Access Compliance Report

Public Rights-of-Way

(Curb Ramps)

Intersection ID: N/A	Main Street: WOODFOX_DR	Cross Street: BURNING_TREE_DR	Location: SE
ADA ID: 1FF7AE0FAFF3	Ramp Type: Directional1	Initial Pass/Fail: Fail	Overall Compliance: No
Severity Score: 12.5			
Codes/Mitigation Info/Possible Solution		Field Measurements/Component Compliance

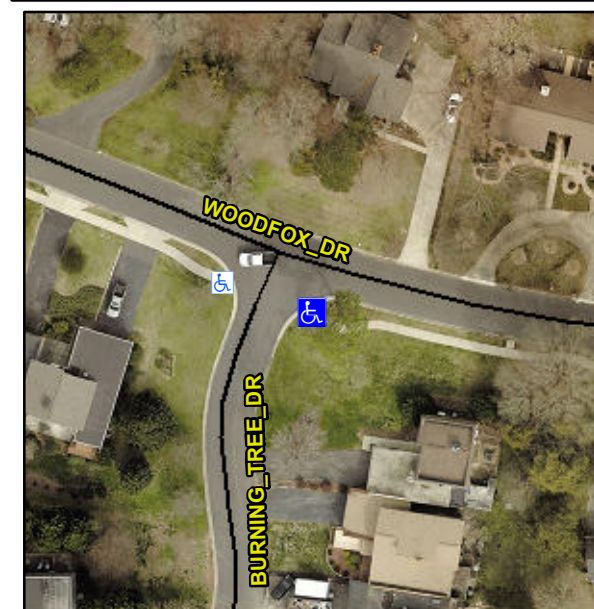
Remove & Replace Entire Ramp.

R304.5.3

Compliance	Description	Data	Compliance	Description	Data
N/A	Ramp Length (in)	71.0	N/A	Grade Break?	N/A
Yes	Ramp Width (in)	60.0	N/A	Grade Break Slope (%)	0.0
Yes	Ramp Slope (%)	1.3	N/A	Grade Break XSlope (%)	0.0
No	Ramp XSlope (%)	5.6			
N/A	Flare Type LT	N/A	N/A	Flare Type RT	N/A
N/A	Flare Slope LT (%)	N/A	N/A	Flare Slope RT (%)	0.0
N/A	Flare Traversable LT?	N/A	N/A	Flare Traversable RT?	N/A
N/A	Landing Length (in)	0.0	N/A	DWS Provided?	N/A
N/A	Landing Width (in)	0.0	N/A	DWS Contrast?	N/A
N/A	Landing Slope (%)	0.0	N/A	DWS Length (in)	N/A
N/A	Landing X Slope (%)	0.0	N/A	DWS Full Width?	N/A
N/A	Landing Curb? (Y/N)	N/A	N/A	DWS Offset LT (in)	N/A
N/A	Shared Landing?	N/A	N/A	DWS Offset RT (in)	N/A
N/A	Gutter Ponding?	0.0	N/A	Gutter Slope (%)	N/A
N/A	Gutter Lip Ht (in)	0.0	N/A	Gutter X Slope (%)	N/A
N/A	Painted X Walk1?	No		Road Slope (%)	7.7
	X Walk 1 Direction	To W		Road X Slope (%)	5.0
	X Walk 1 Width (in)	N/A		Clear Space?	N/A
